SERVICE NO. 1140B BULLETIN

Date: July 22, 2026

**OXYGEN GENERATOR PROTECTIVE CAP AND
TUBE REMOVAL**

SB 1140B adds oxygen generator part number.

Figure 1 (Sheet 1 of 2)
Oxygen System Installation

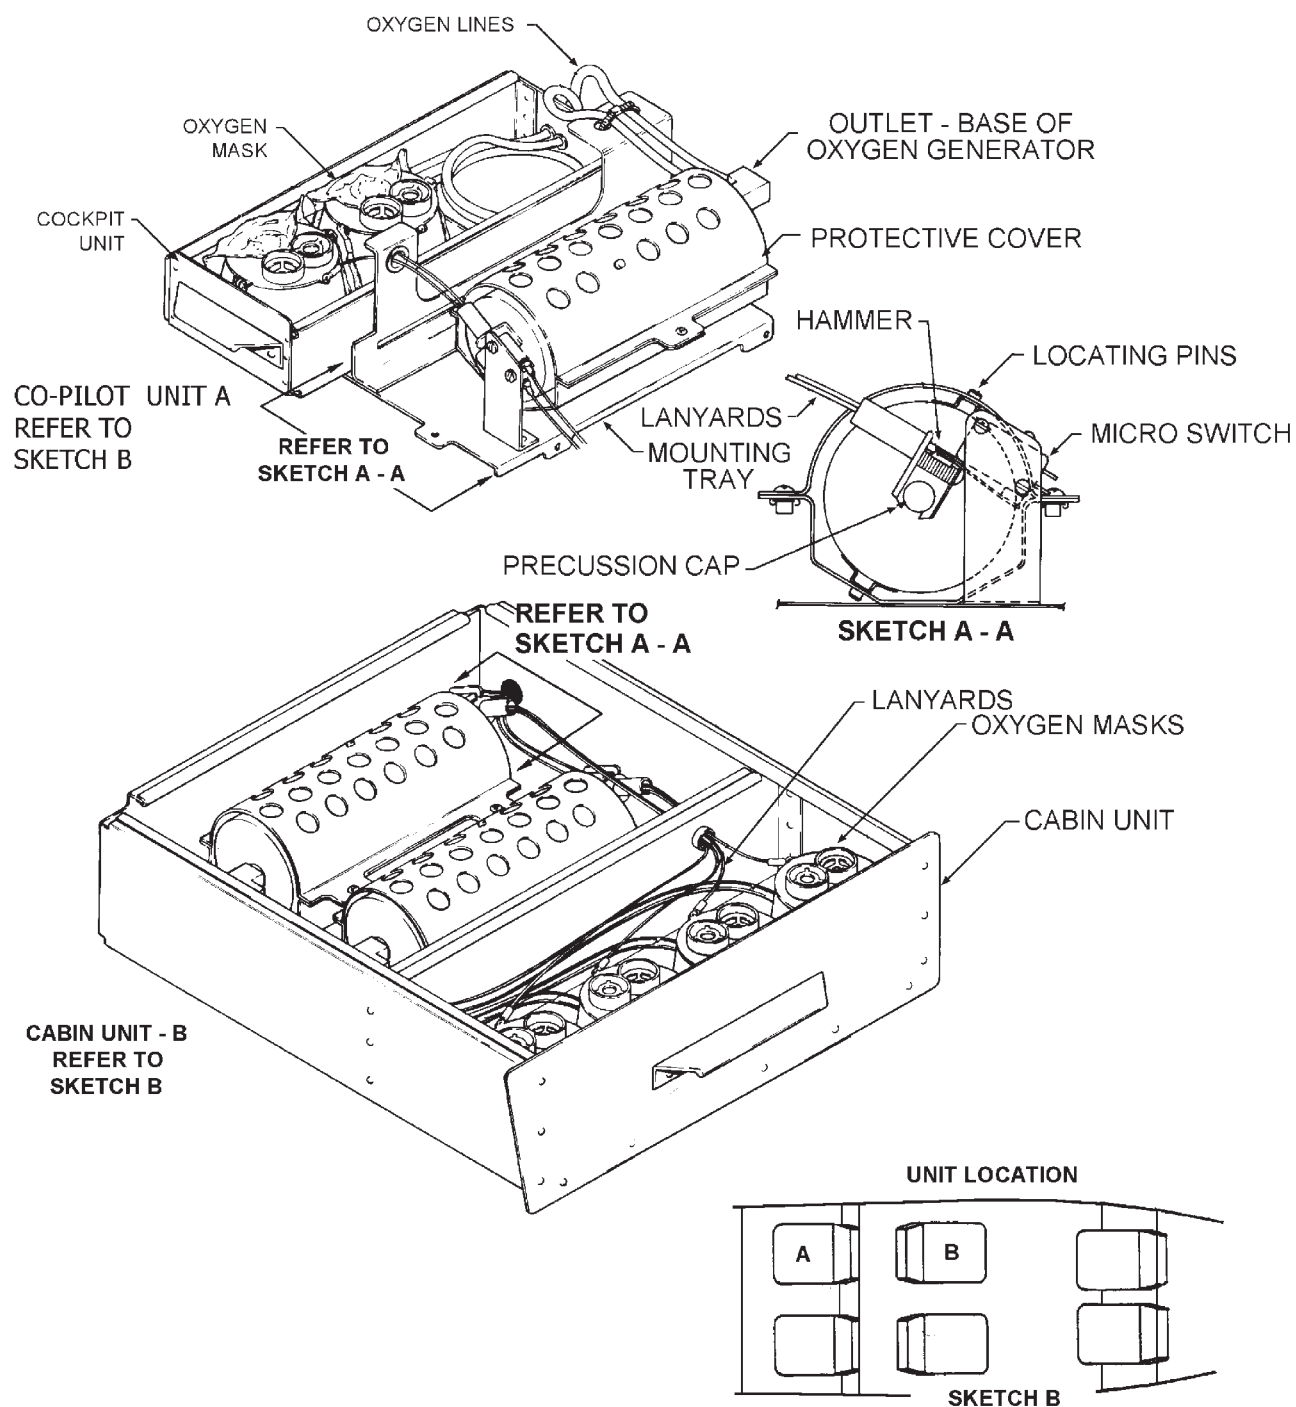
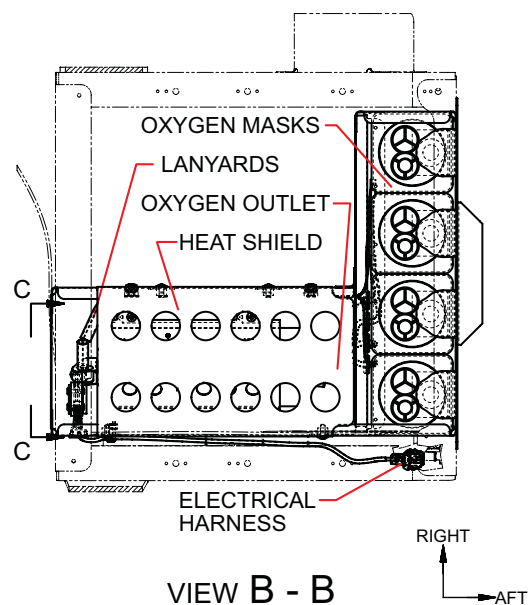
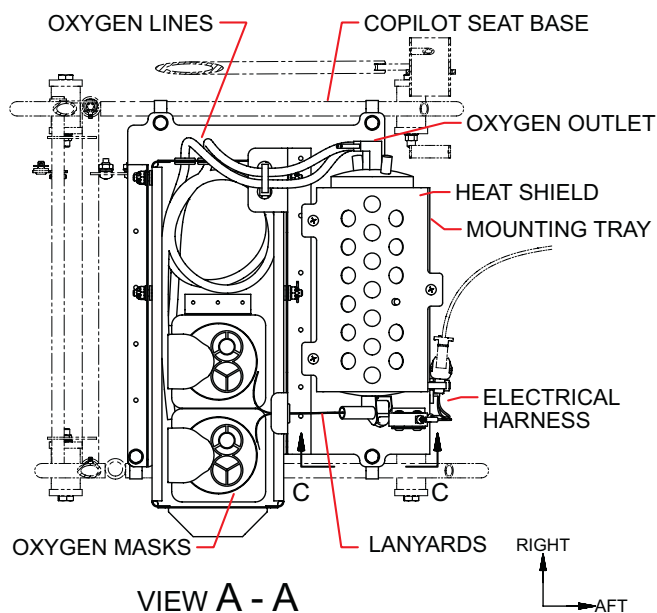
1. Locate the oxygen generators, Piper P/N's 471-025 or 557-805, underneath the co-pilot's seat and the RH, aft facing, rear seat. See Figure 1.

Figure 2
Oxygen Generator Safety Equipment Installation

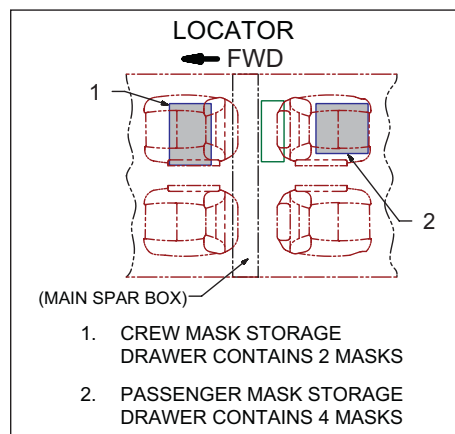
2. Examine the end of each oxygen generator where the percussion cap is located, see Figures 1 and 2, for presence of a yellow colored, protective cover and/or a silicon tube installed over the end of the trigger mechanism pin. If no protective covers or silicone tubes are found in the area shown in Figure 2, no further action is required, proceed to Step 4.

3. If the yellow protective covers are found on any of the oxygen generator percussion caps, they must be removed. In addition, a silicon tube may also be installed over the end of the trigger mechanism pin, this tube may be secured to the protective cover by a safety pin. These components must also be removed. Remove protective covers, silicon tubes, and safety pins, see Figure 2, as follows:

CAUTION: WHEN REMOVING PROTECTIVE COVERS AND/OR SILICON TUBES, ENSURE ALL THREE COMPONENTS SHOWN IN FIGURE 2 ARE REMOVED, AS REQUIRED.

- a. Remove the yellow colored protective cover from the percussion cap.
 - b. If the silicon tube is installed, grasp it with needle nose pliers and pull to remove the tube and protective cover from the oxygen generator.
4. Make a logbook entry documenting compliance with this service bulletin.
